RO Question #61

Question RO#61

GLENN CW DELTA T (RUN ON 12/22/2014 10:32:37 AM)

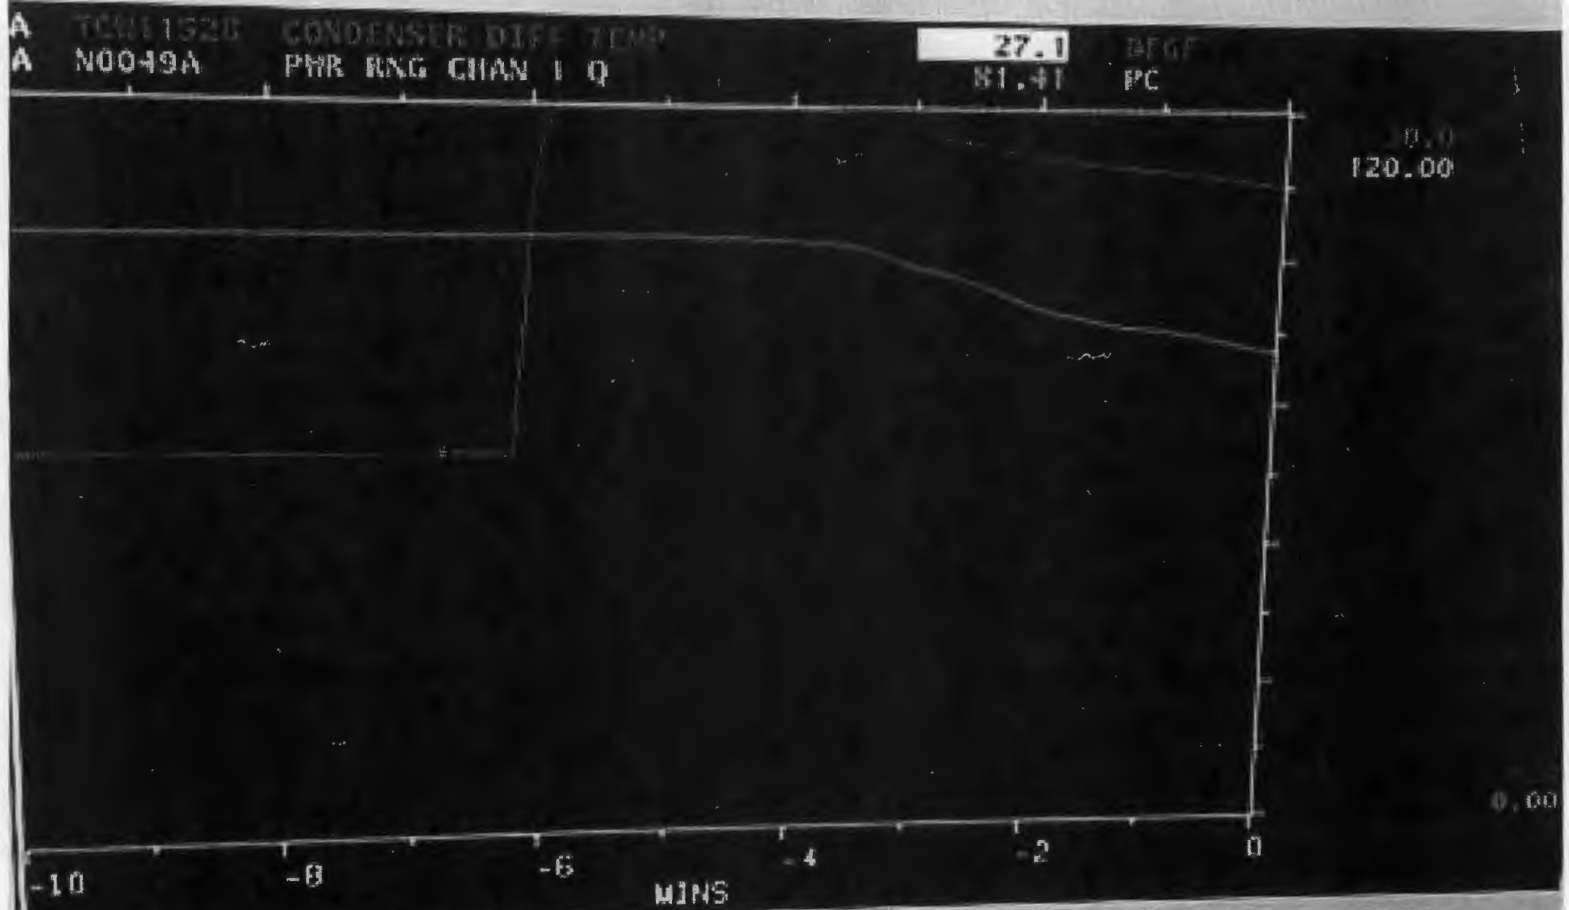
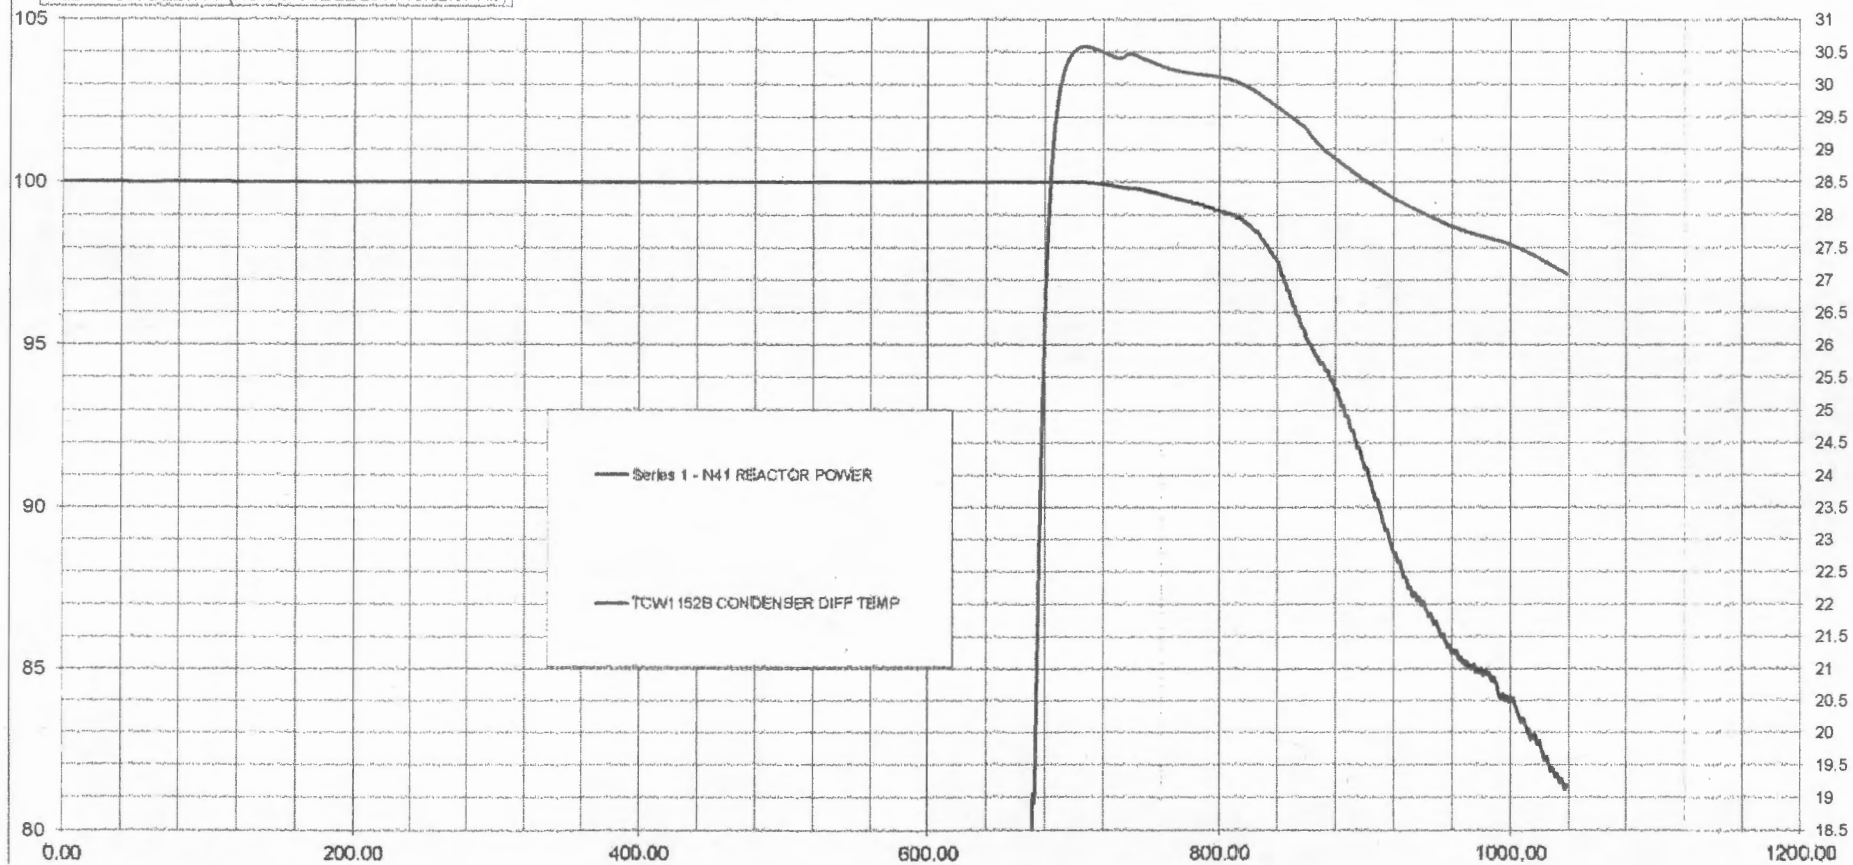
Based on their knowledge of plant response to a loss of circulators, 4 of 8 SRO candidates assumed that condenser ΔT would rise rapidly and exceed the 27°F limit, and based their answer on having to do a rapid load reduction to some power level below 83%. The accompanying simulator charts reflecting a breaker failure on the 2-6 500KV breaker corroborates that rapid rise in condenser temperature, and the necessity for initiating the power reduction. As shown on the Plant Computer screen shot, Rx power was lowered to approximately 81% to reduce Condenser ΔT to 27.1°F. An additional simulator computer graph shows that a Rx power reduction to 81% power was required to lower condenser ΔT to 27 °F.

Licensee Recommendation: The licensee proposed that Choice c be accepted as an additional correct response. According to the licensee, several applicants assumed that for the given conditions that condenser delta-T would increase rapidly, therefore the Continuous Action Summary of S1.OP-AB.CW-0001 would come into effect because condenser delta-T would exceed 27 °F. This would require the crew to initiate a load reduction in accordance with S1.OP-AB.LOAD-0001, thus making Choice c to be a correct response. The applicants' assumption was substantiated by a simulator plant computer screen shot showing the rapid increase in condenser delta-T when the conditions provided in the question were run on the simulator and, within a short period of time, condenser delta-T reached 30°F.

NRC Conclusion: This question was initially acceptable for the examination based upon the (incorrect) premise that the Continuous Action Summary would not come into effect. However, based upon the simulator modeling of condenser delta-T for the given conditions, the NRC concluded that Choice c is a correct response. The NRC will accept Choices c and d as correct responses to this question.

205342 A 8763-76

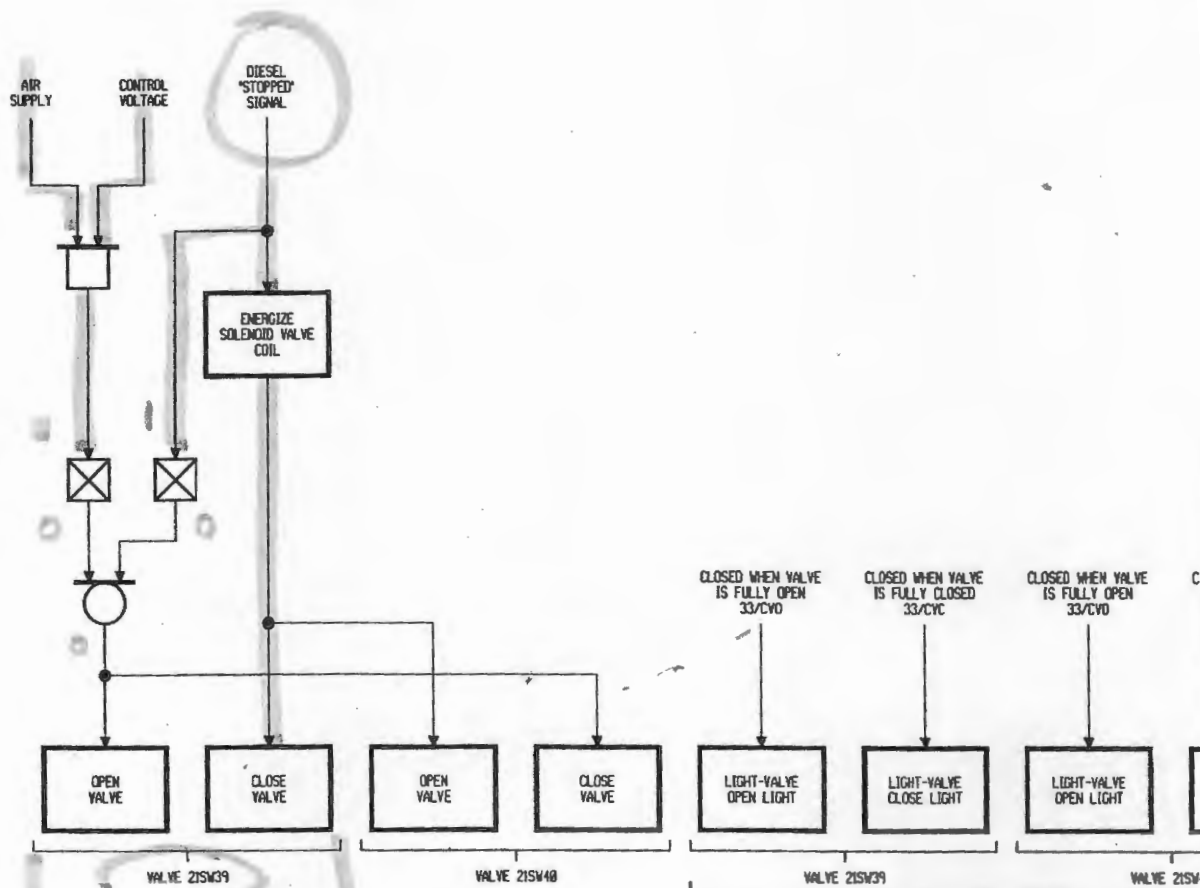
There is no correct answer to question #8. As shown on drawing 205342, Sheet 3, the 22SW39 is the 2B EDG Jacket Water and Lube Oil Coolers SW Supply Valve, which is normally **closed** with the EDG out of service. The 2A, 2B, and 2C EDGs are normally out of service, and no indication was given in stem that 2B EDG was in service. A leak on the EDG Lube Oil Cooler will not reduce SW Header pressure. Drawing 246689 shows that when the EDG is stopped the SW39 is demanded closed and does not go open until the EDG is started. There is an additional choice (b), which also had a leak location on a line which is normally out of service, so it cannot be assumed that the leak location was active.

with
225W39-X
(normal position)
2B EDG LO
cooler leak
would be
invisible in
control room.

Licensee Recommendation: The licensee proposed to delete this question based upon there is no correct answer. For the given plant conditions (no emergency diesel generators running), the service water supply header isolation valves (SW39s) would already be closed. These valves are normally closed and are open if their respective EDG is running. Therefore, if a leak developed on the 2B EDG Lube Oil Cooler (Choice c), it would not reduce SW header pressure because the oil cooler is already isolated. The proposal to delete this question is based up the SW flow path on Drawing 205342 Sheet 3 and the valve control logic on Drawing 246689.

NRC Conclusion: This question was initially acceptable for the examination based upon the (incorrect) premise that the service supply header isolation valves (SW39s) were in the open position. However, based upon the plant conditions provided in the question, and documentation supporting that these valves would have already been closed, The NRC concluded that Choice c is incorrect. The NRC will delete this question based upon the determination that there is no correct answer.
